Australian Competition and
Consumer Commission

**EnergyAustralia Regulatory
Review**

Capital Expenditure and Asset Base,
Operational Expenditure and Service
Standards

March 2004

Figure 3 Comparison of Historical Capex against Capex Allowed in 1999 Decision

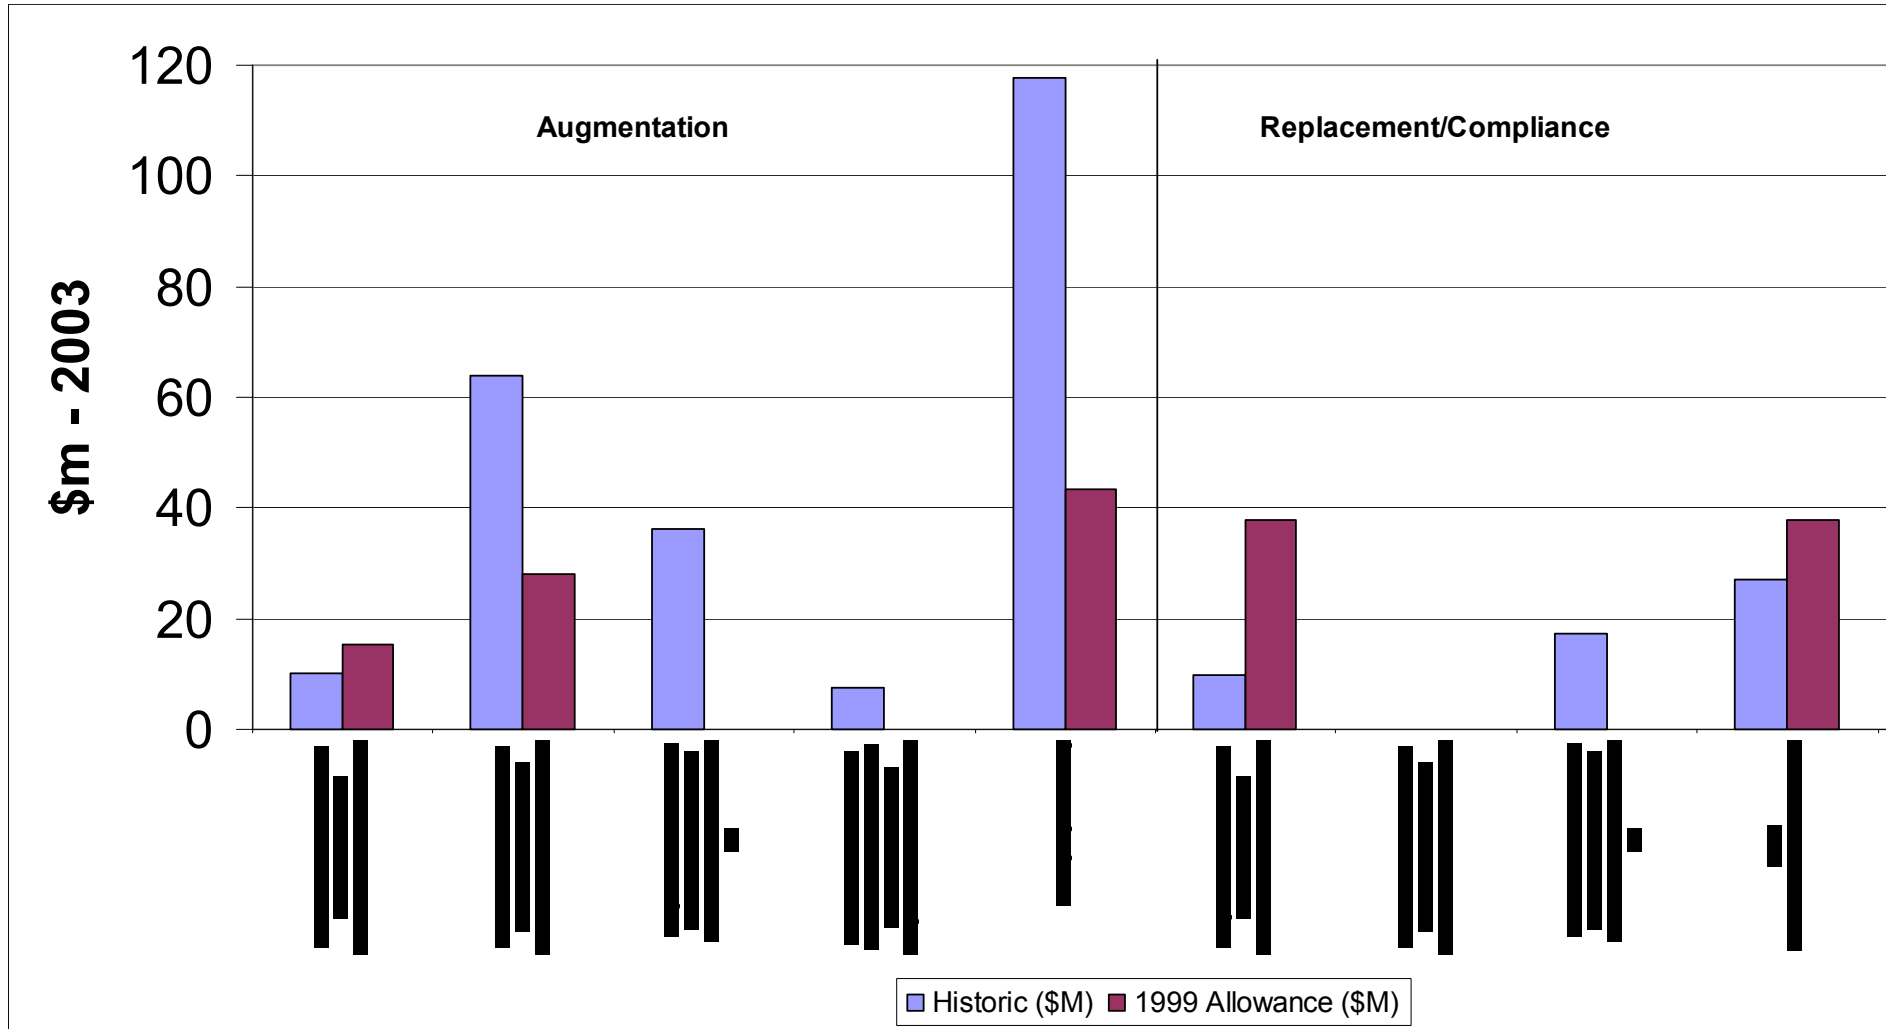
The above comparison indicates:

Figure 4 Original Asset Definition; Global ORC Allocation

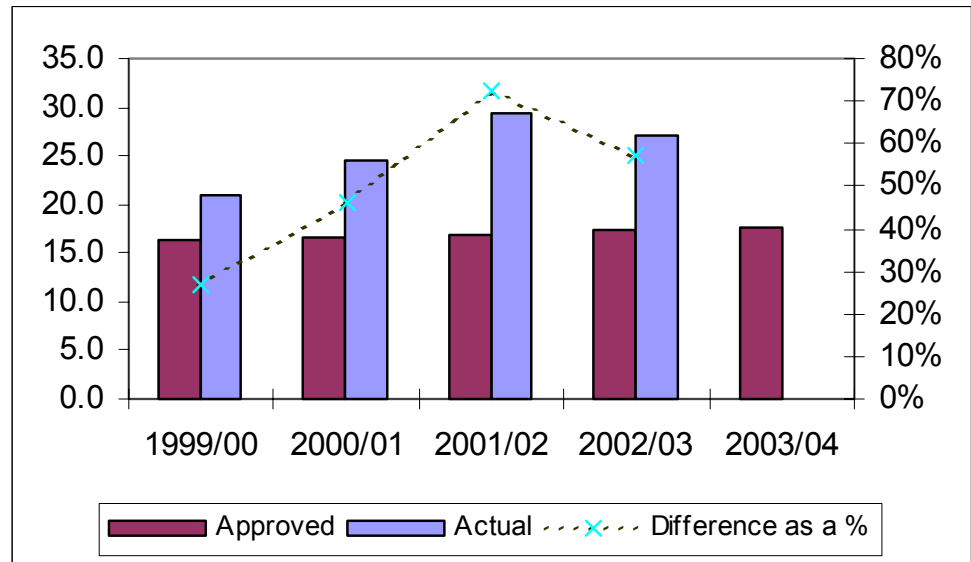
The average difference between the actual and the approved Opex was 51%. This is clearly far above what GHD would have expected and on face value it is not reasonable. We have explored these differences below.

Figure 9 Historic Opex and Starting Point: Proposed Allocation Method

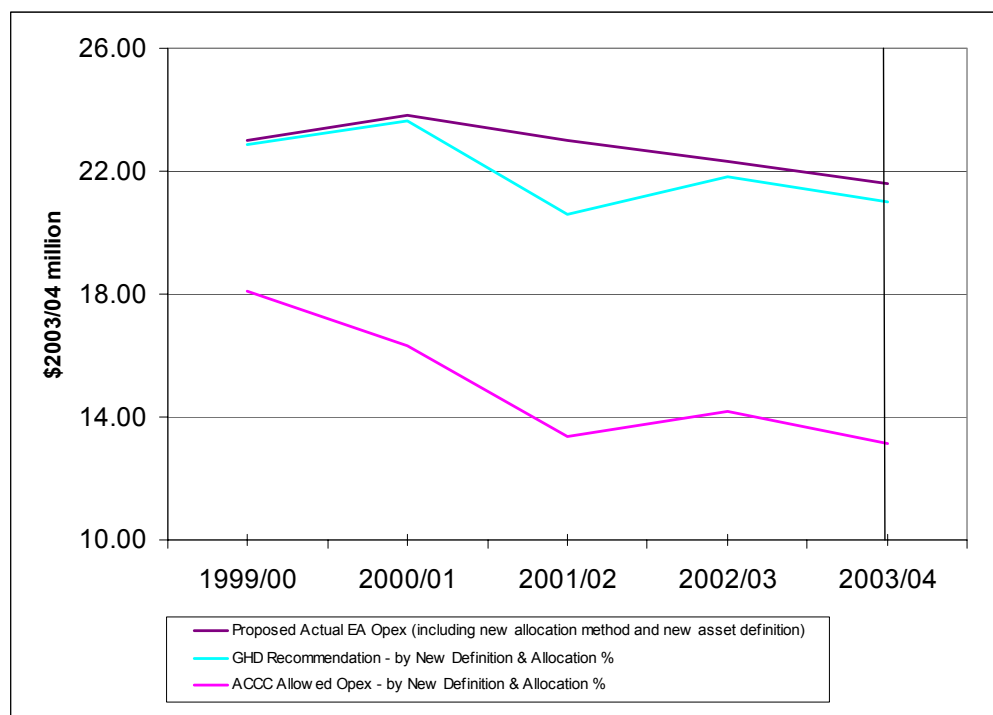
The GHD proposed starting point is \$20.986m using the new asset definition and allocation methodology. The GHD proposed starting point variation is \$0.604m less than the proposed EnergyAustralia starting point. This is displayed graphically in Figure 9.

Figure 11 Comparison of Time Based and Condition Based Forecasts

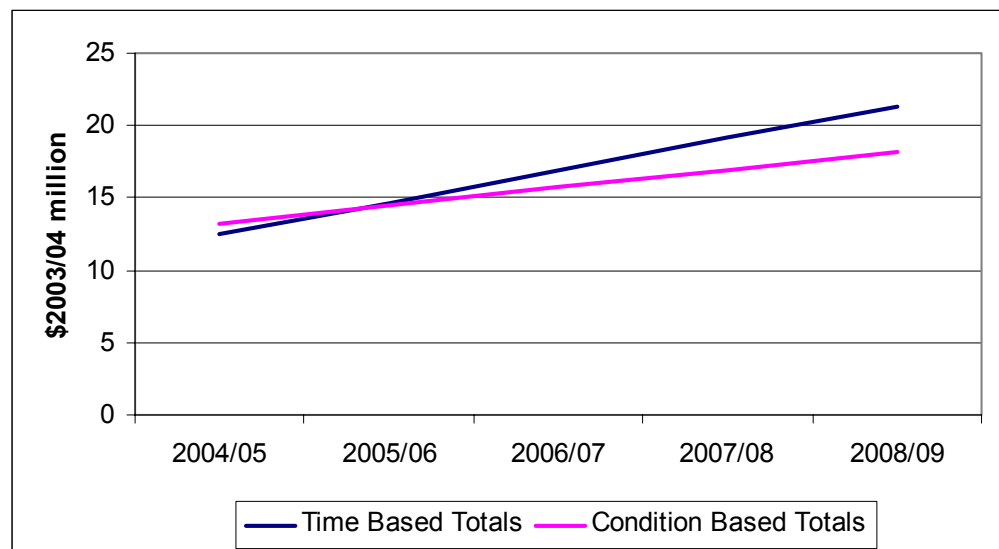
GHD supports the move by EnergyAustralia to RCM, and supports the forecast put forward by EnergyAustralia.

Figure 13 10-Year Summary of Opex Findings

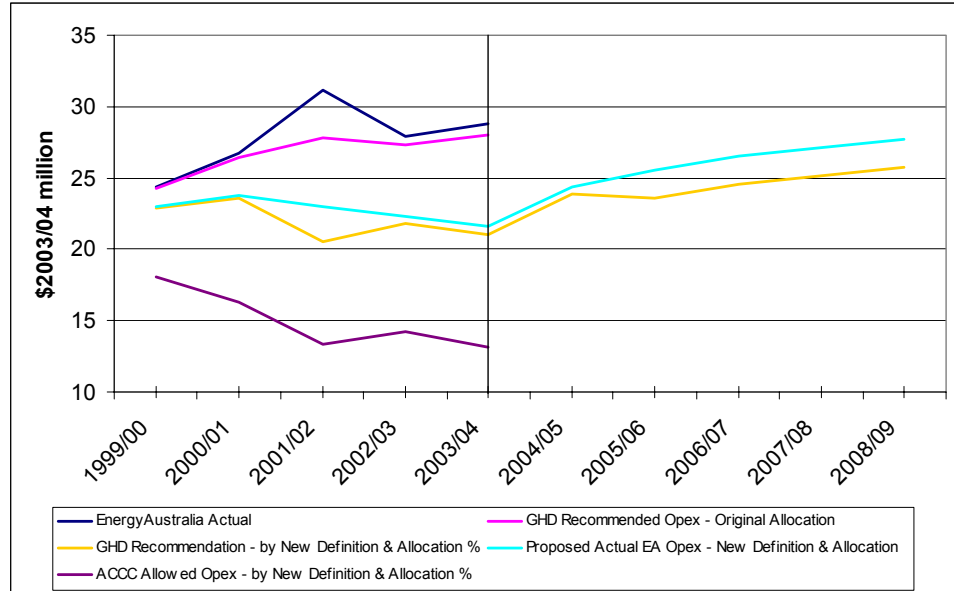
The GHD recommendation is still significantly above the 1999 ACCC Opex decision, with many observations not being included into the GHD recommendation due to a lack of evidence to conclude that expenditure as wither prudent or non-prudent.
